**SAFETY  
RECALL**

**SR17-31**

DATE :	May 2018	SECTION :	23 ACCESSORIES
SUBJECT:	2½ lb AND 5 lb FIRE EXTINGUISHER REPLACEMENT

FIGURE 4

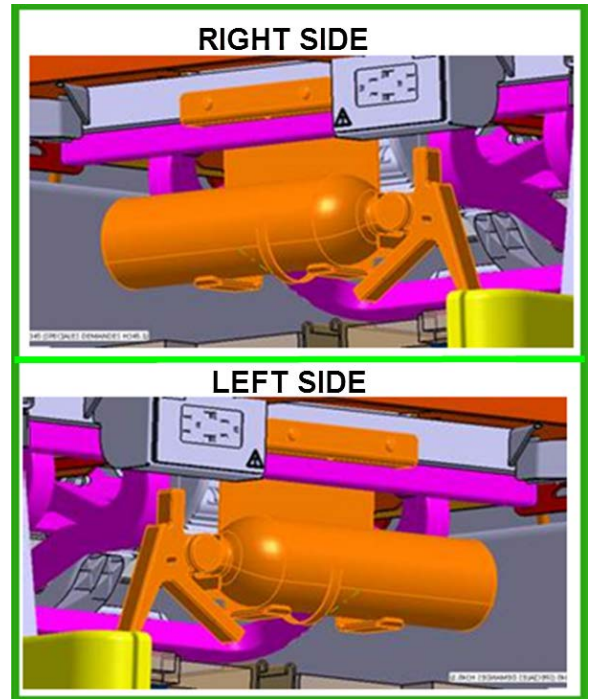
3. To avoid interference between the handle and the seat, orientate both new extinguisher handles down as shown on Figure 4.
4. Bulletin is complete for these vehicle models.

FIGURE 8

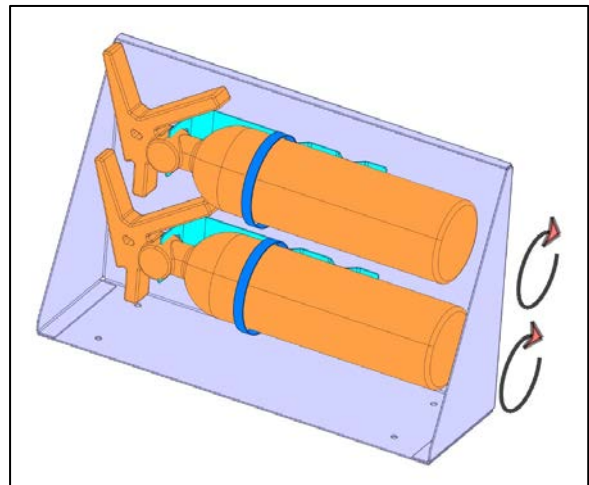
7. To avoid interference between the metal handle of the first fire extinguisher and the cylinder of the second fire extinguisher, turn slightly and apply the same angle to both fire extinguishers (Figure 8).
8. Bulletin is complete for these vehicle models.

**FIGURE 9**

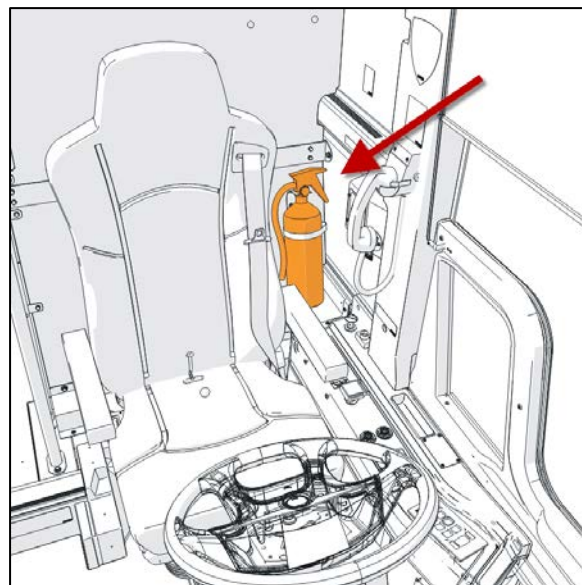
9. Locate the existing 5-lb fire extinguisher behind the driver's seat of the vehicle.

<b>NOTE</b>
Figure 9 shows the installation when the vehicle was delivered. Location of the fire extinguisher might be different.

**FIGURE 11**

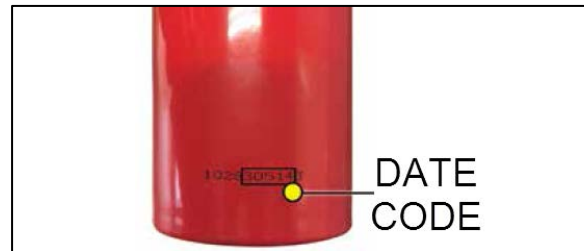
Figure 11 shows the location of the 10-digit date code on the side of the cylinder. Digits 5 through 9 represent the day and year.

All fire extinguishers with the date code XXXX29715X (October 24, 2015) or later have to be replaced.
